VKBA 3532

Technical Bulletin – December 2015

FORD: Focus, Fiesta V. Car model codes: DAW/DBW/DFW/DNW
MAZDA 2

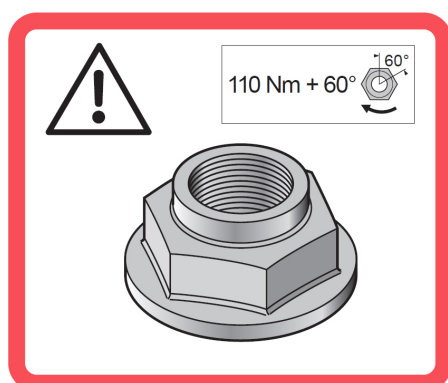
Caution, when fitting the wheel bearing kit VKBA 3532, it's mandatory to use the new nut included in the kit. Never reuse an old nut!

SKF has decided to change the nut in VKBA 3532, due to updated FORD OE recommendations.

Note: The included nut at kit VKBA 3532 has a new design and needs a different torque compared to the old design. It is crucial to follow the instructions when torquing the new nut since this is a **safety aspect**. See torque values stated at the warning label below.
